**Staff Report to the Hearing Examiner
5412 North 49th Street (Nguyen) Accessory Dwelling
Conditional Use Permit
CUP 16-02**

The proponent has applied to the City of Ruston for approval of a conditional use permit to construct an attached accessory dwelling above the garage of a new single family residence. The single family residence, accessory dwelling and garage will all be new construction upon the site which is currently vacant.

BASIC SITE PLAN

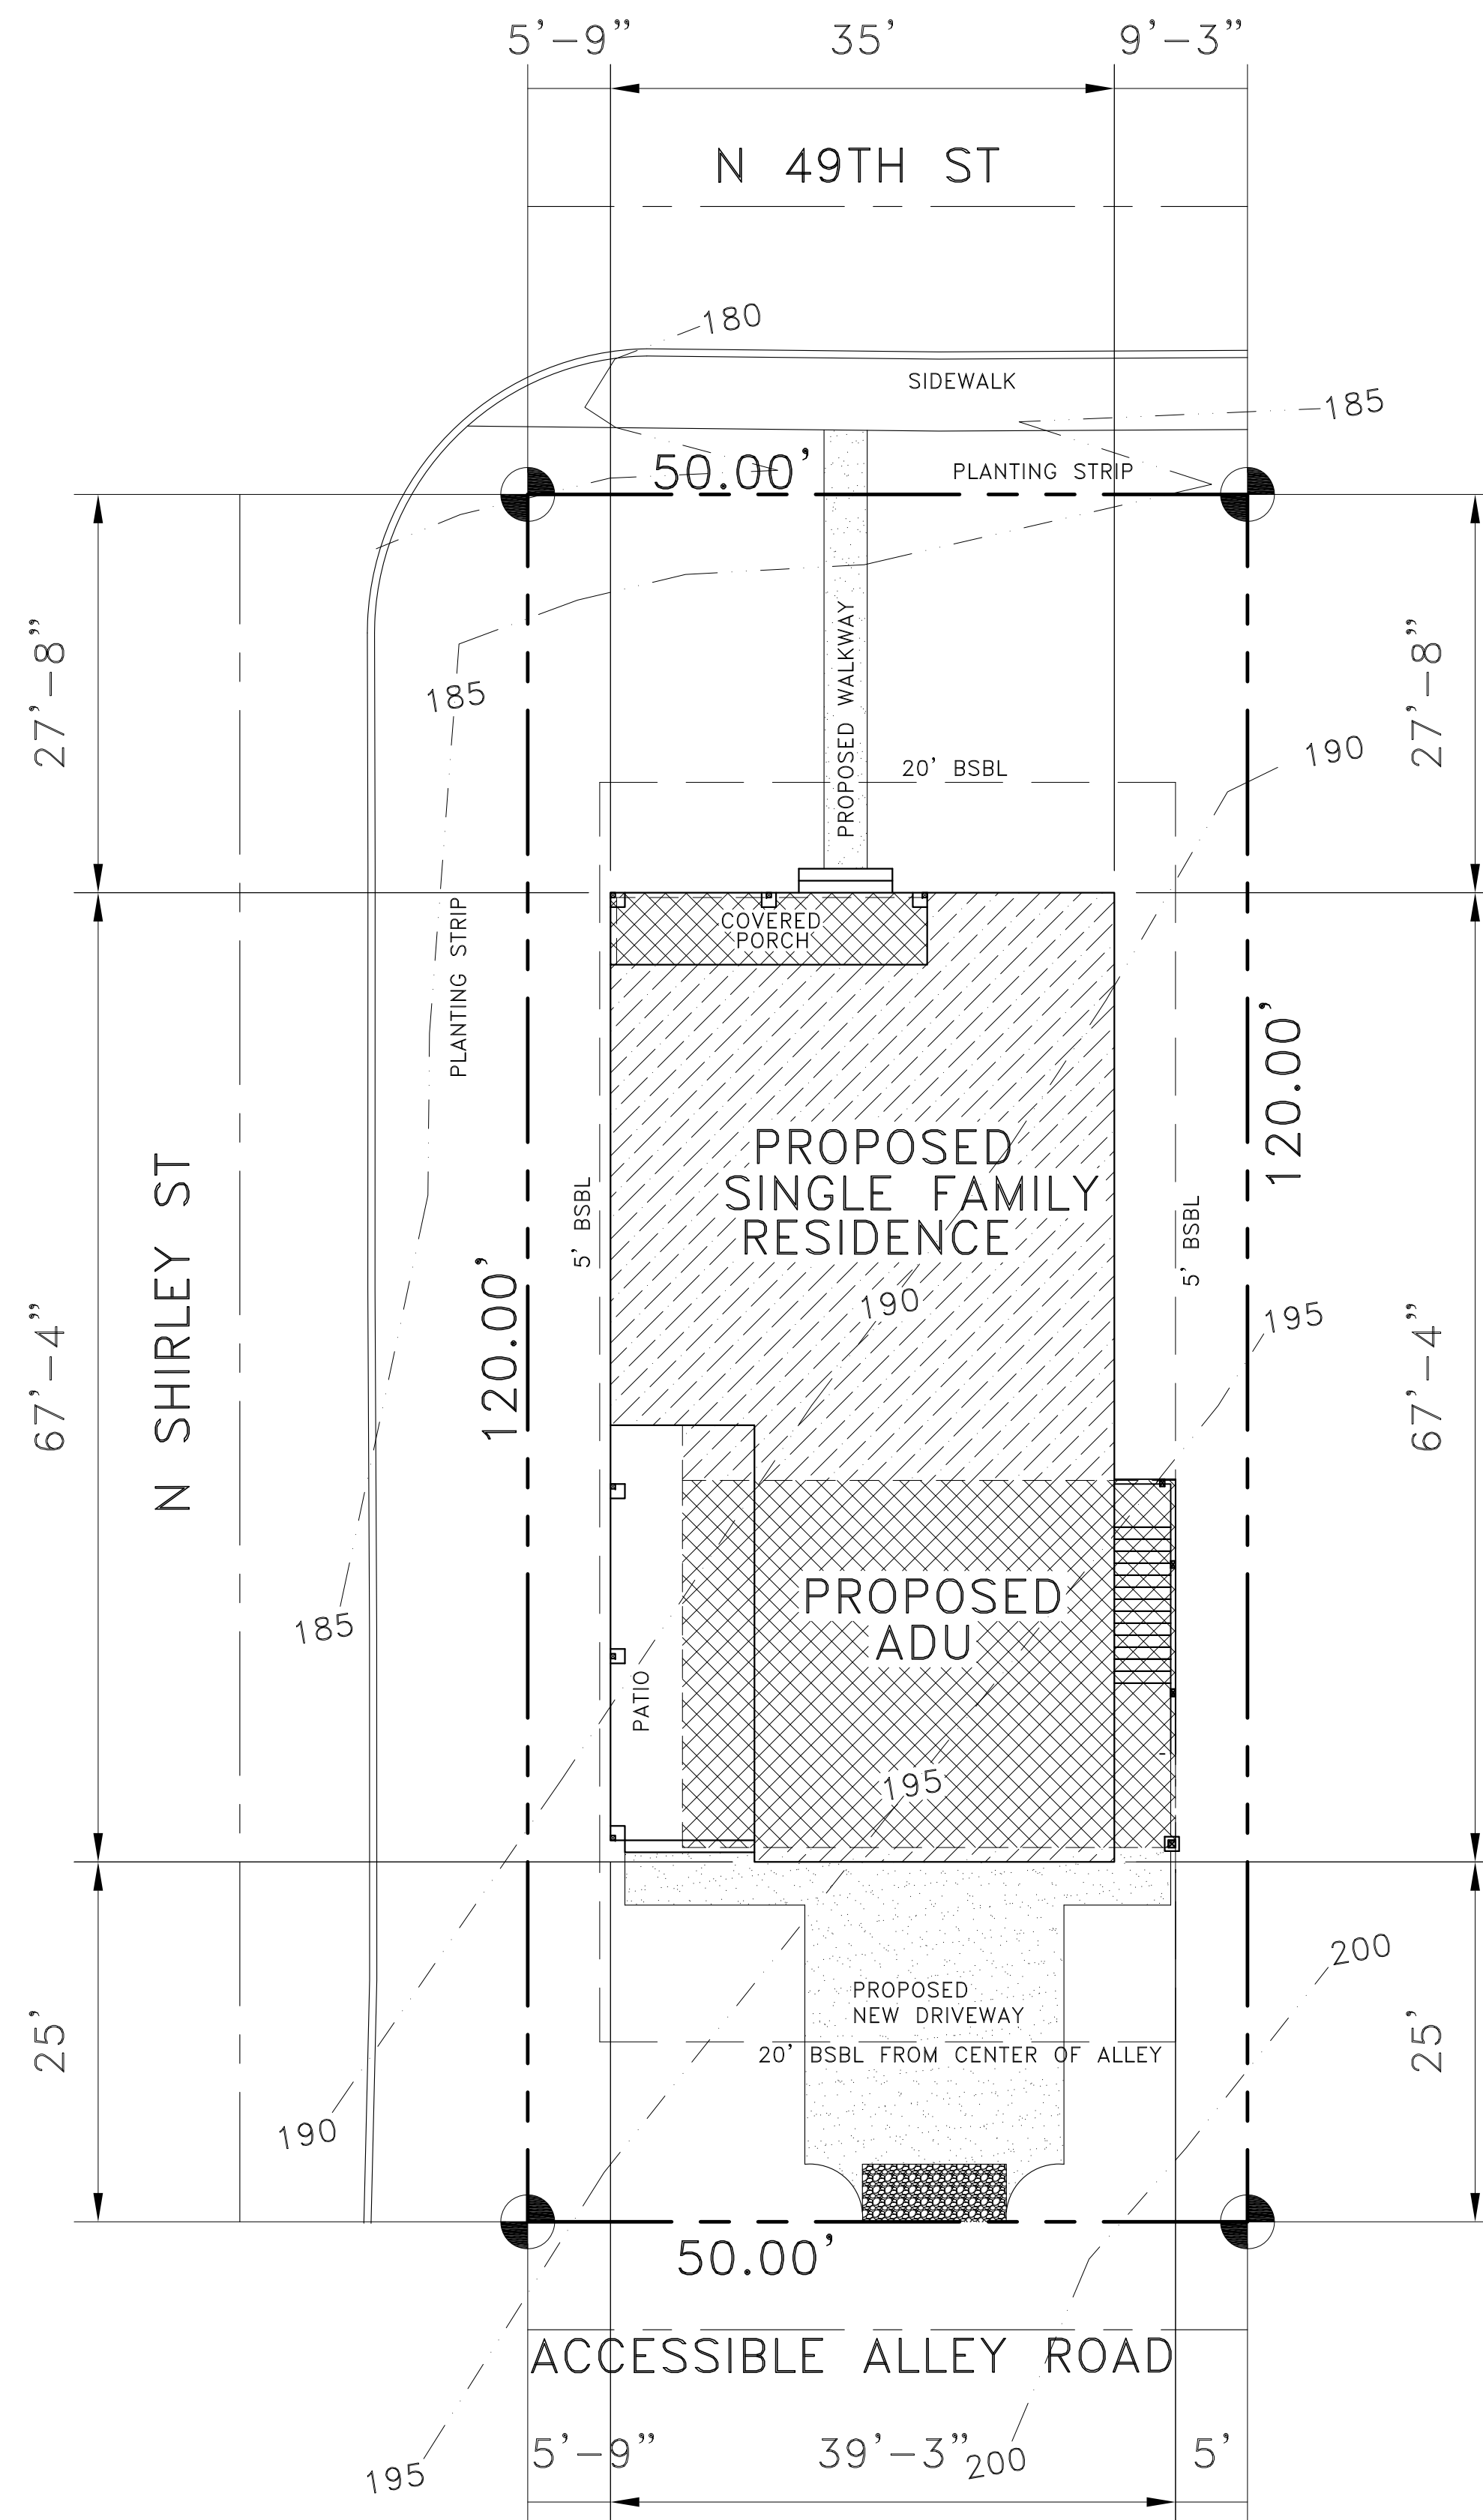
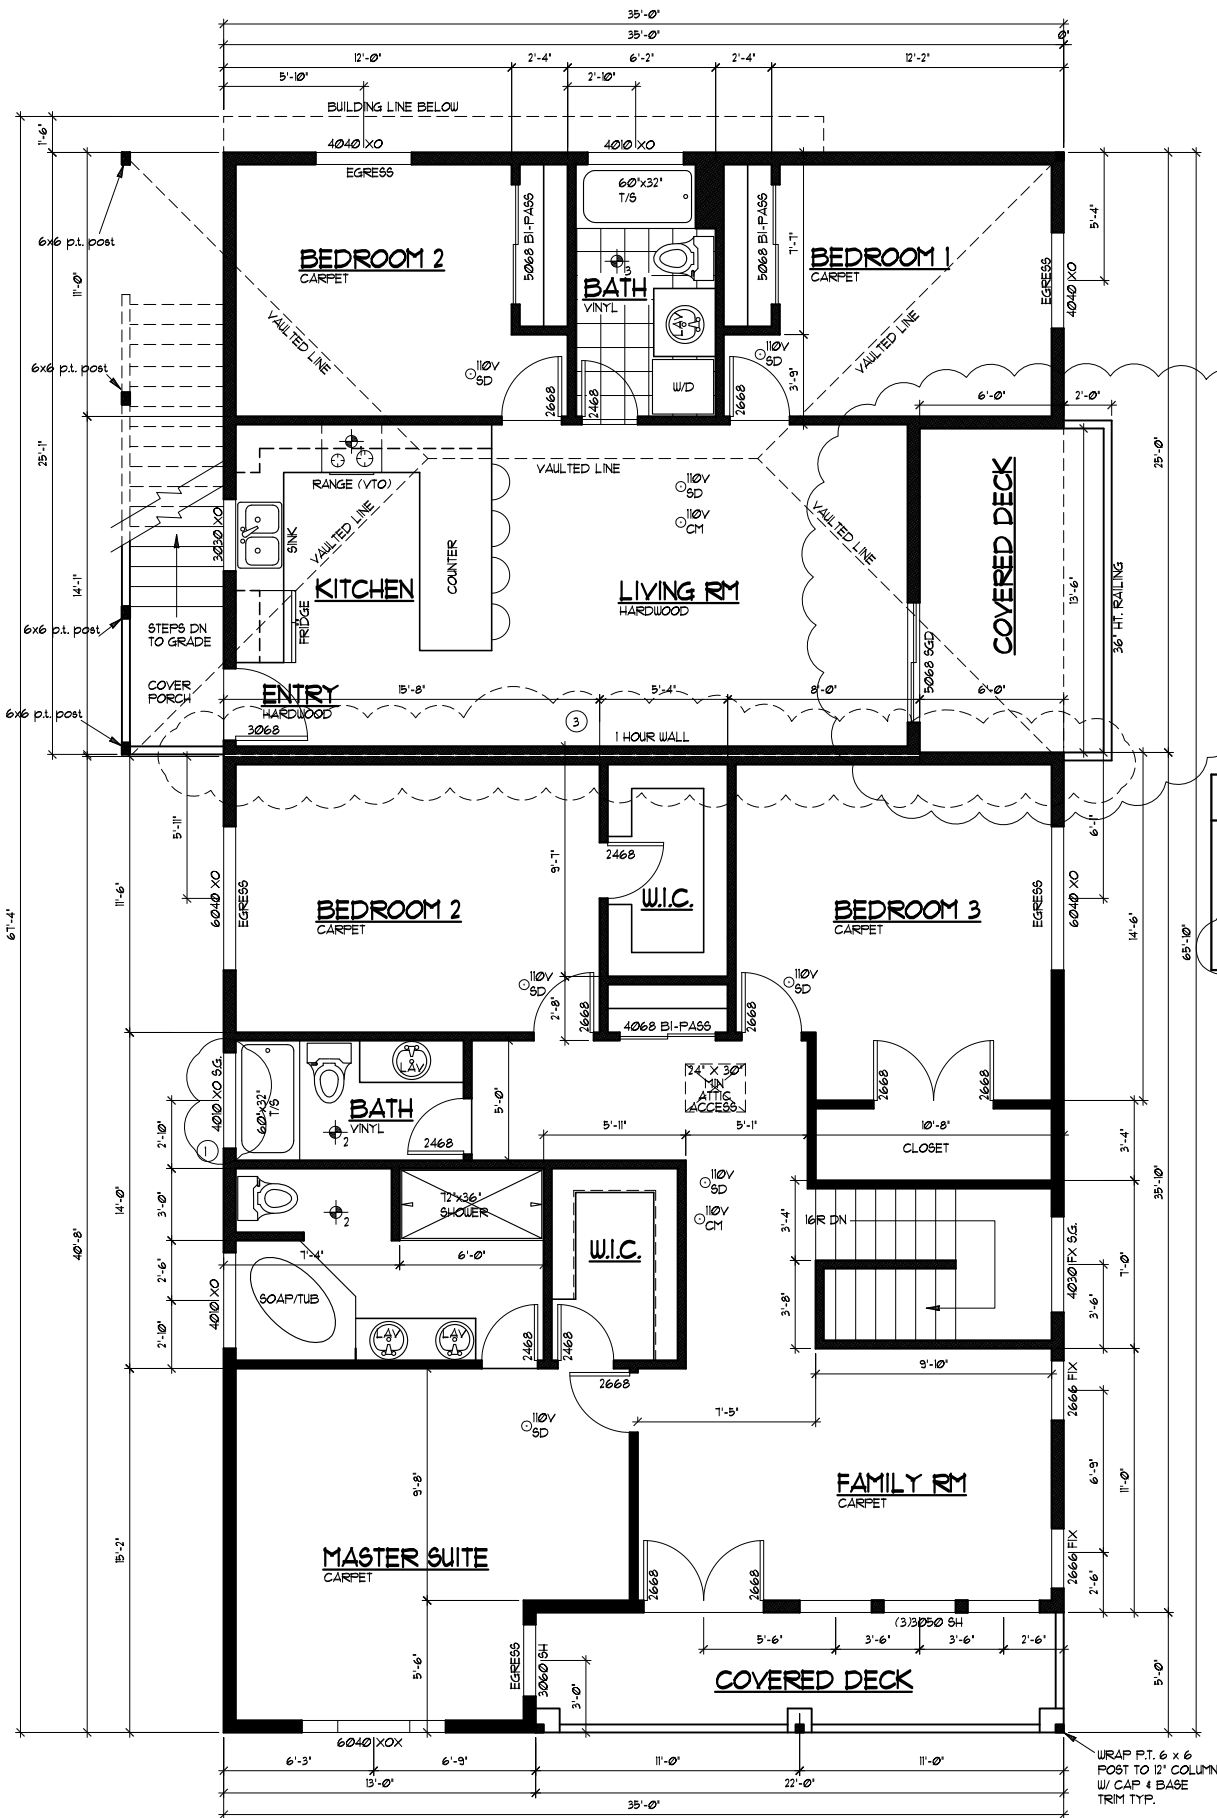
- a. The site plan shall be revised to include a minimum 3-foot wide pedestrian route connecting the pedestrian entrance and the sidewalk along the Shirley Street frontage. Outdoor lighting which complies with the City's outdoor lighting standards shall be provided at the pedestrian entrance, and at typical intervals along the route.

- b. The site plan shall be revised to include a designated location for storage of solid waste and recycling containers for both the primary residence and the accessory dwelling unit.
